Subject: **Request for Modification of Section 404 General Permit No. 198200031 and Section 401 Water Quality Certification, and lifting of Notice of Violation Status** for the Interstate 85 (I-85) widening and interchange improvements from north of NC 73 to north of SR 1280, Cabarrus and Rowan Counties, Divisions 9 and 10. Federal Aid Project No. NHIMF-085-2(61)55, TIP I-3802A.

The North Carolina Department of Transportation (NCDOT) requests modification to the existing General Permit No. 198200031 and associated Water Quality Certification for widening and interchange improvements along I-85 in Cabarrus and Rowan Counties. This project is currently under construction.

Revisions have been made to seventeen impact sites and are discussed in detail below. Two new impact sites are also discussed below (Site 36 and the Troutman waste site).

**SITE #10**

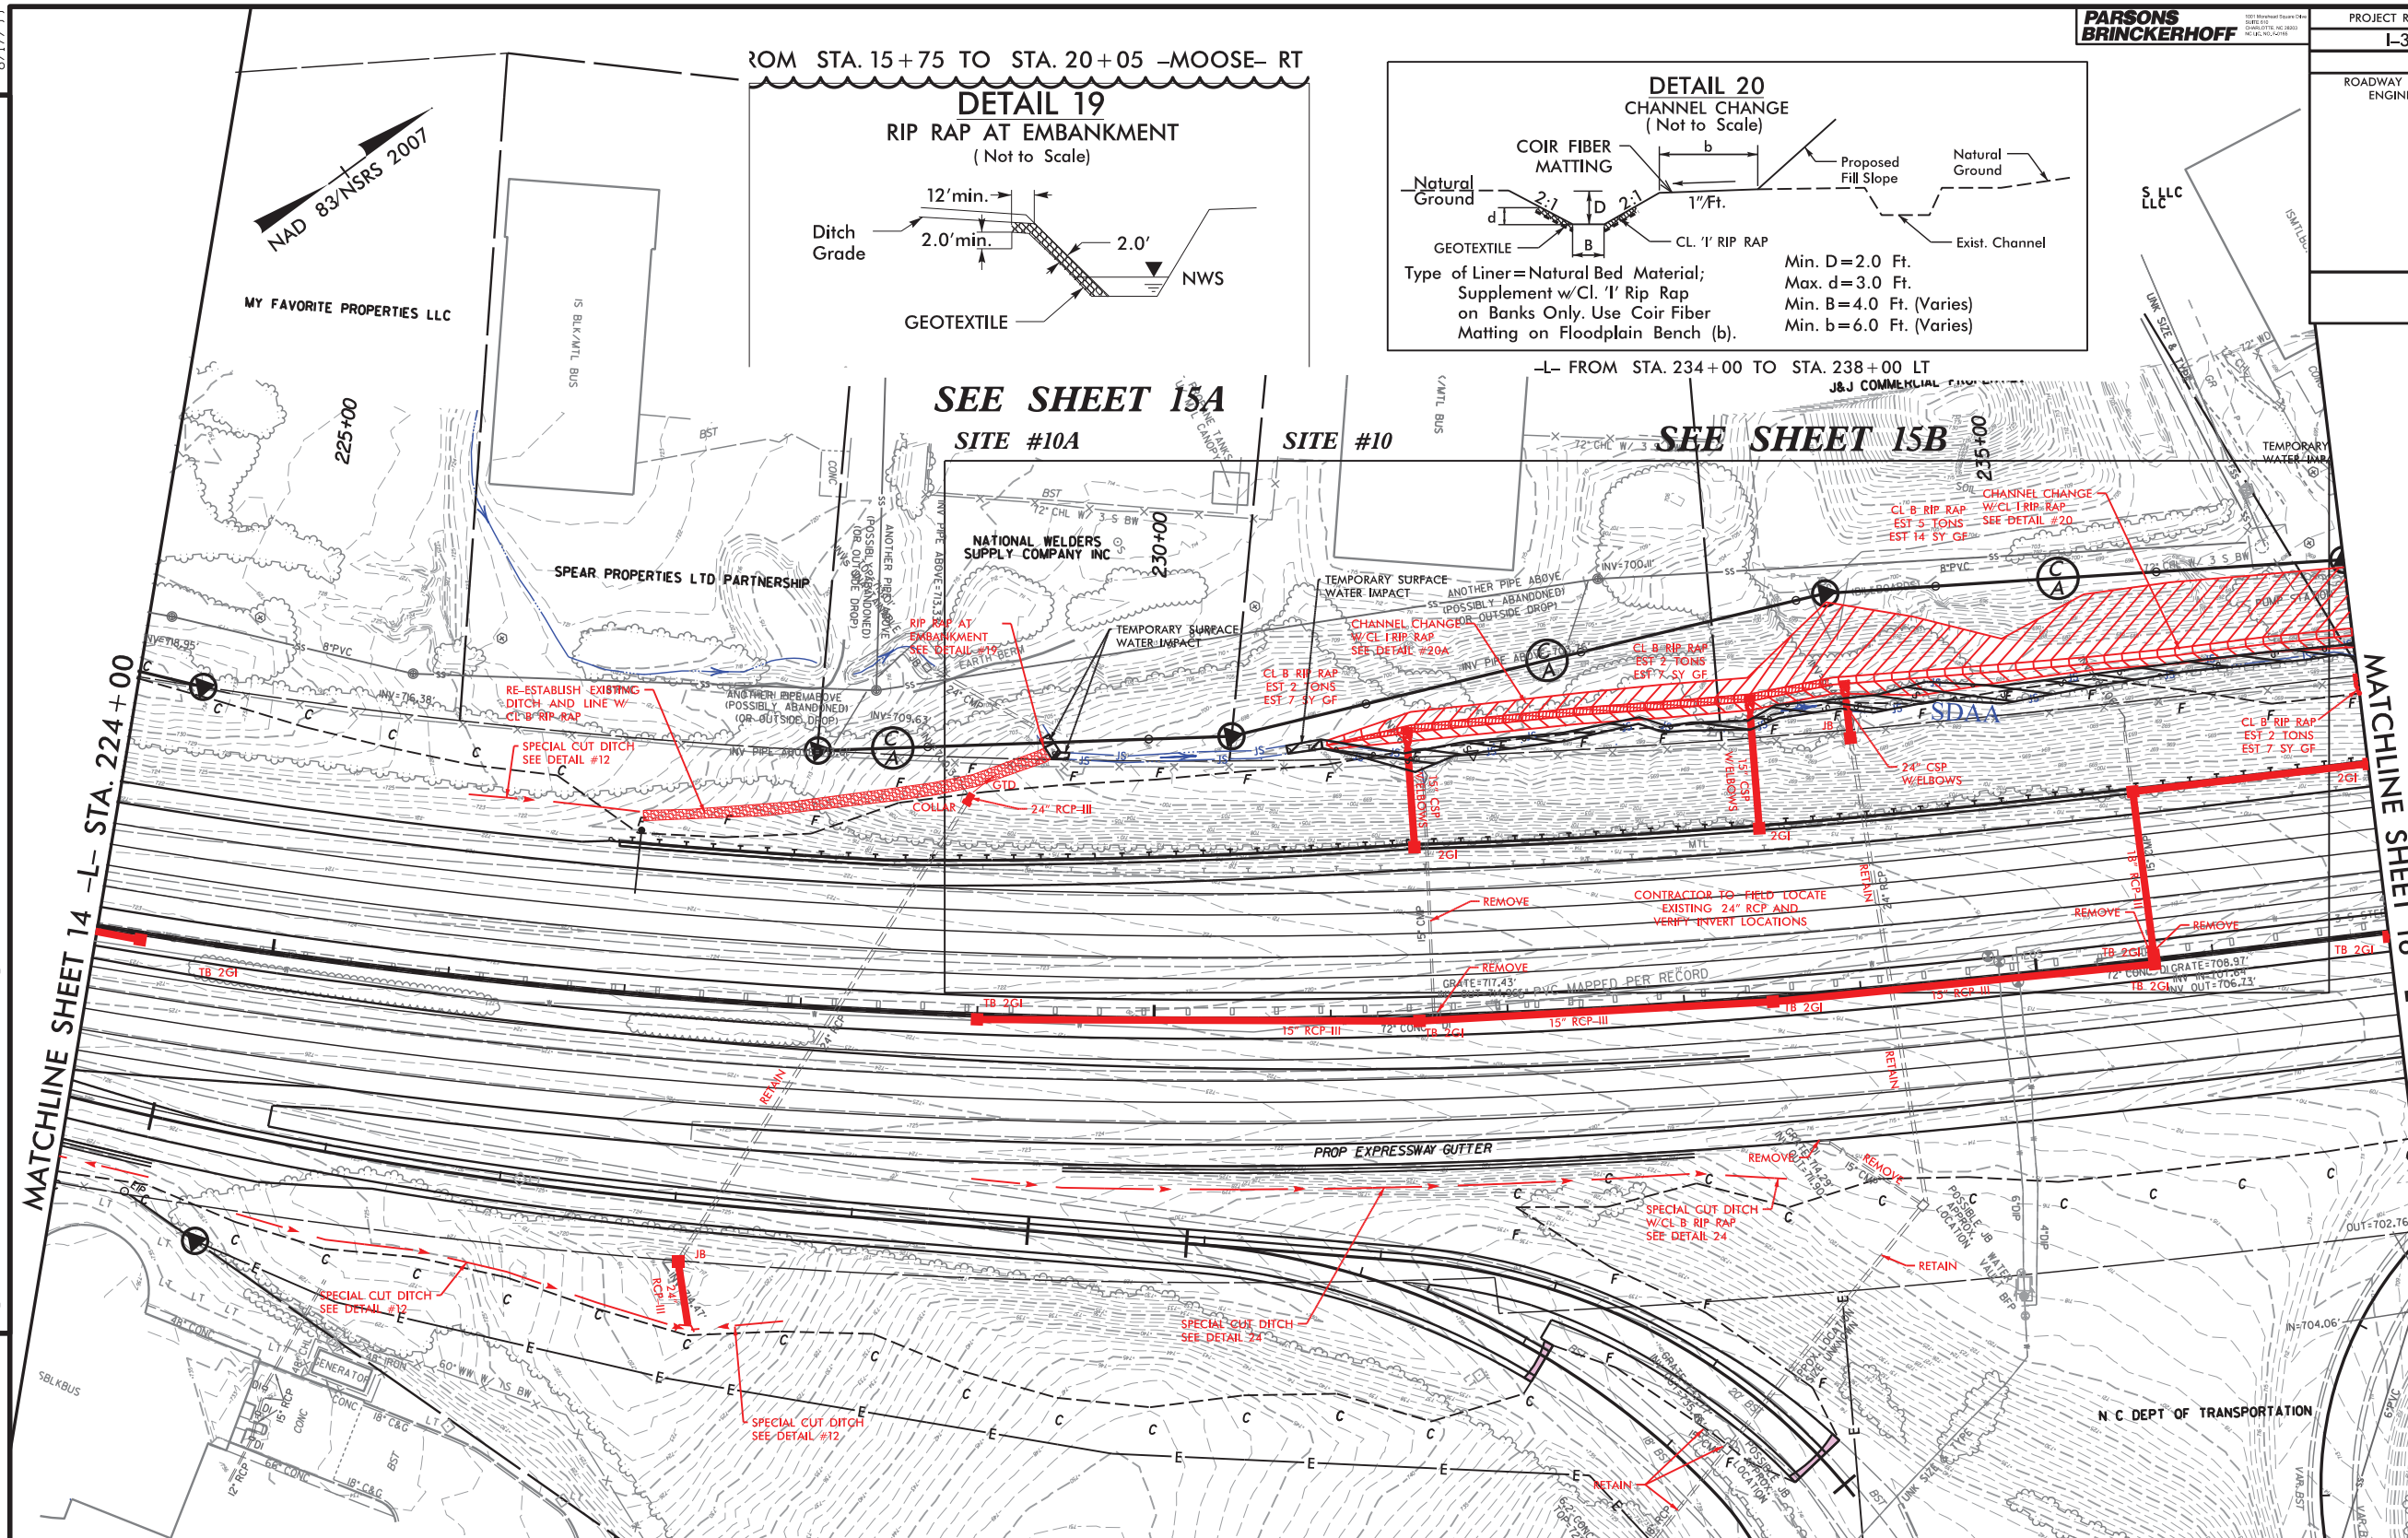
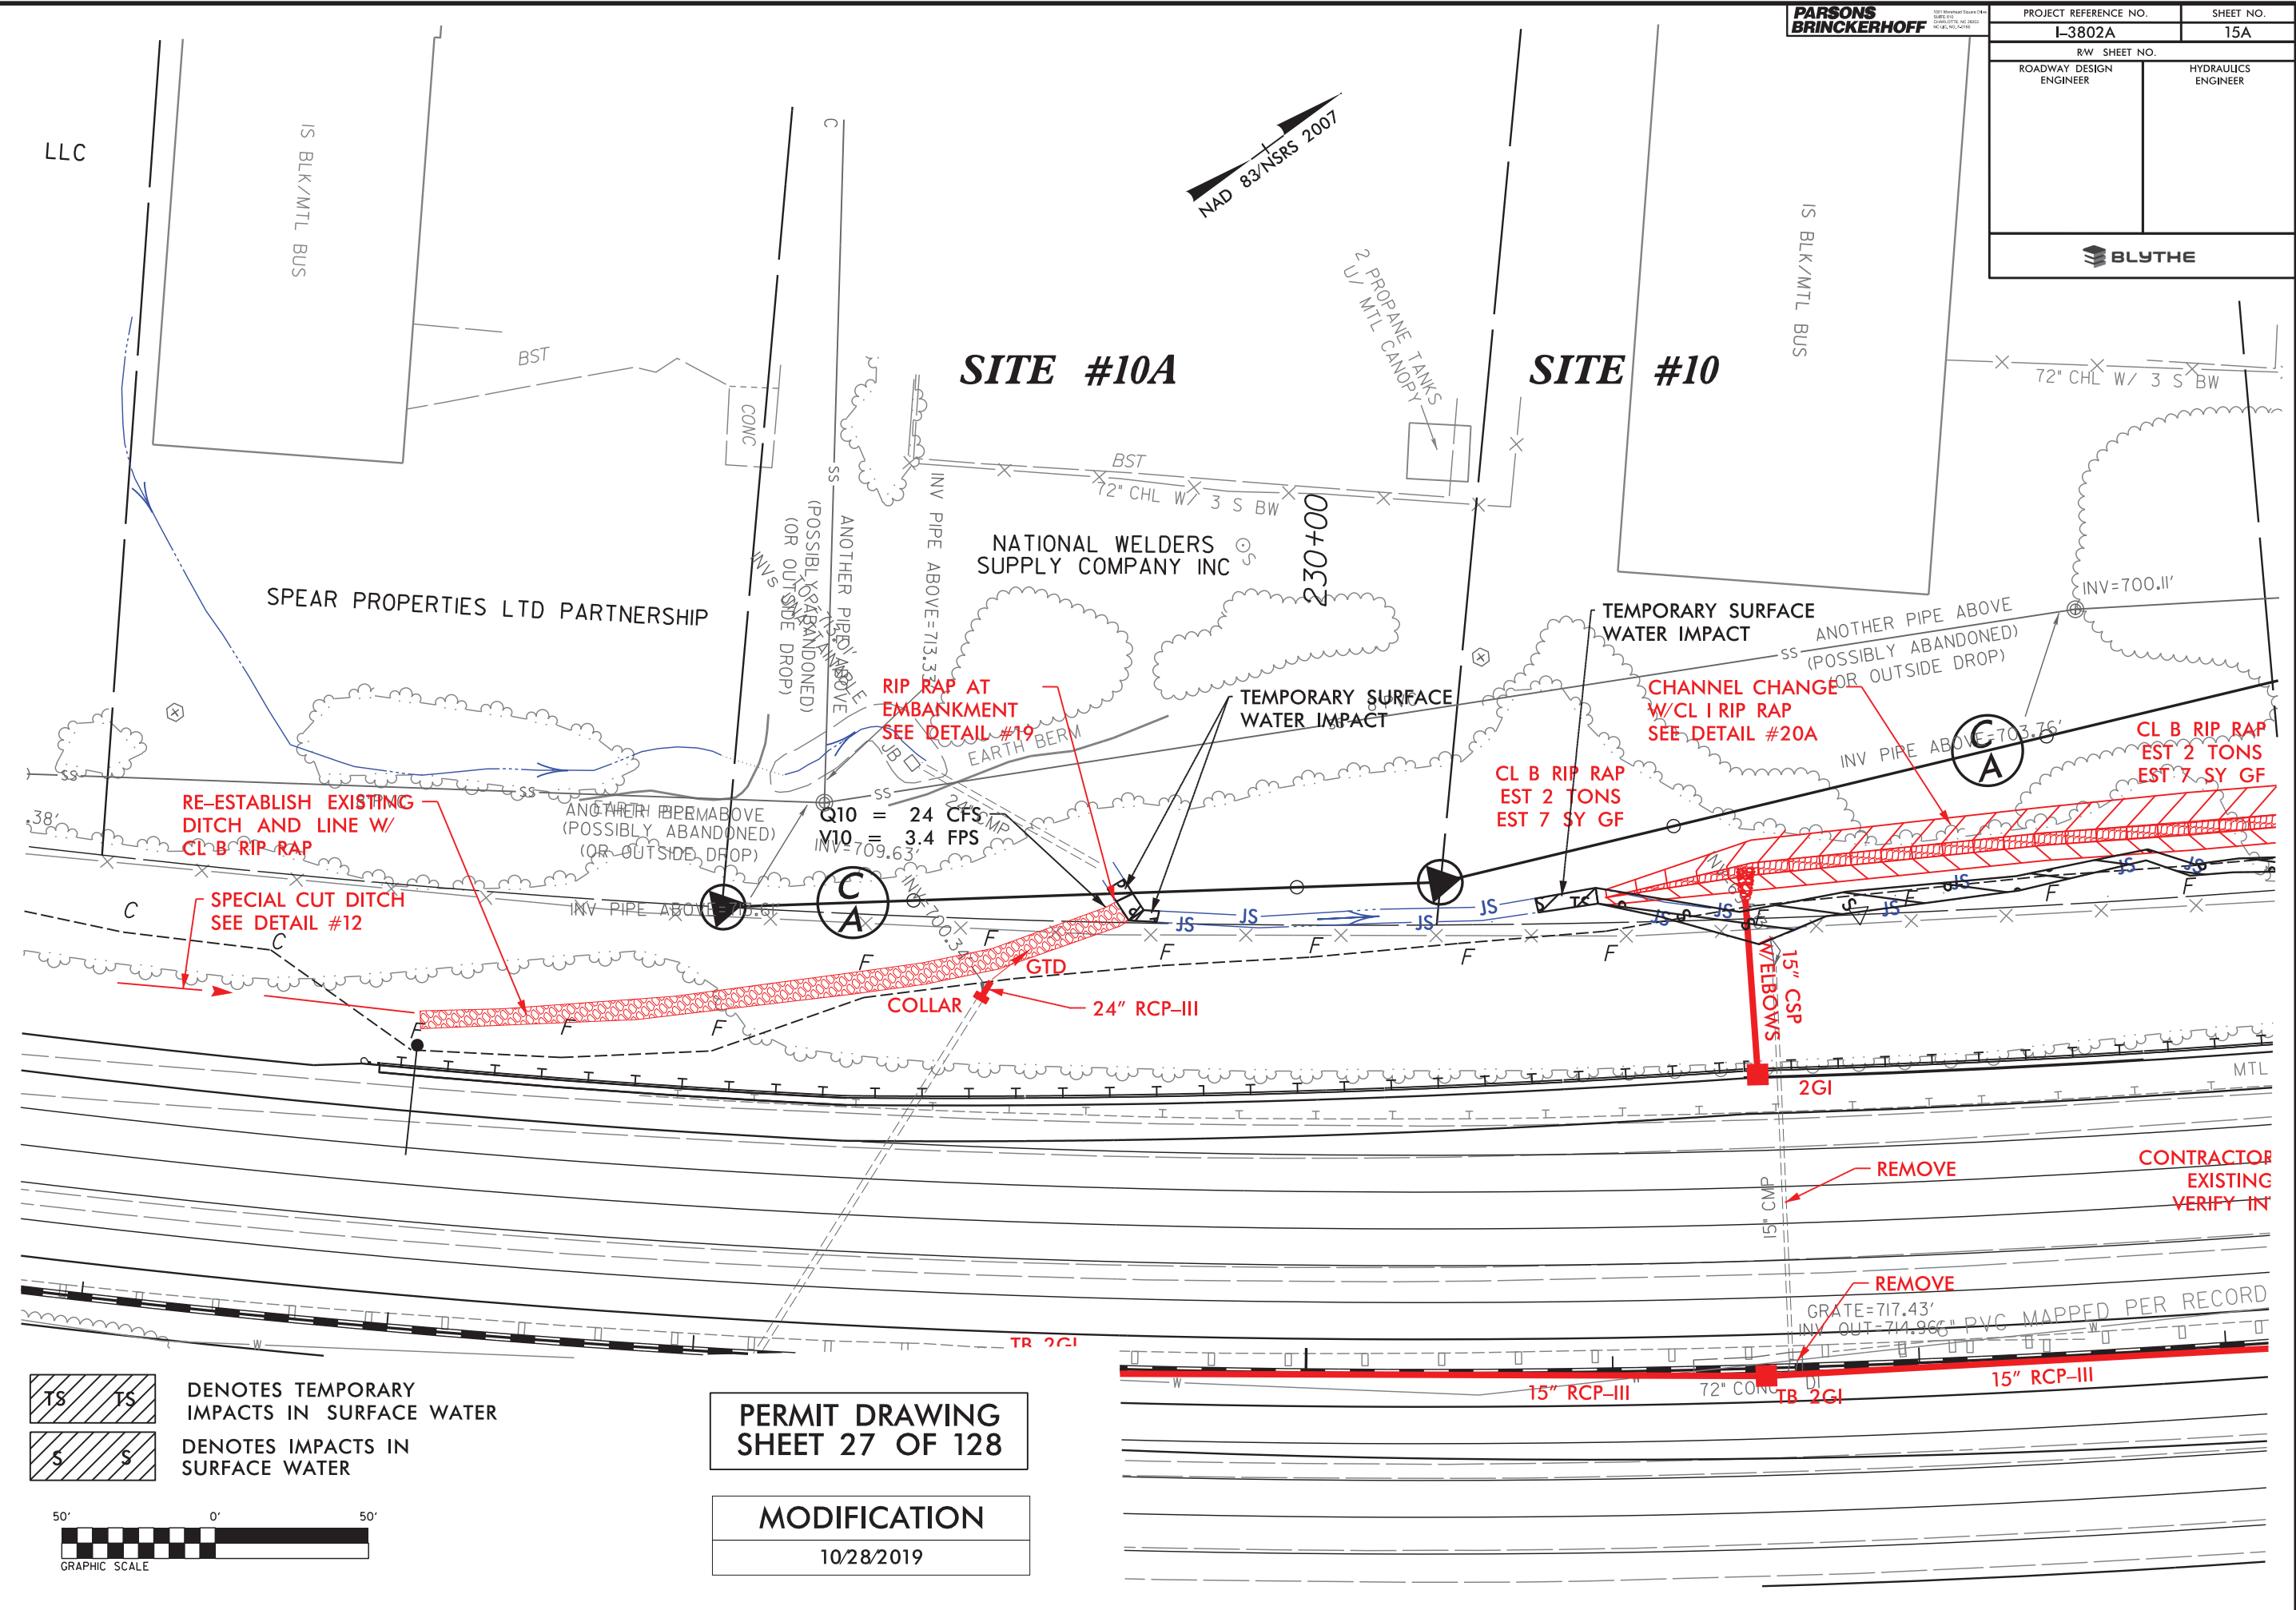
Site 10 (Sheet 15) – The permitted drainage design included a channel change with rip rap only on the banks for stream SDAA. Class I rip rap was installed in the bottom of the channel change for 300 linear feet to provide additional stabilization to address stability concerns. Also, the channel change was shortened by 20 linear feet to make a smoother transition to existing stream channel. Permanent stream impacts were reduced from 666 linear feet to 646 linear feet, which is 20 linear feet of less impacts.
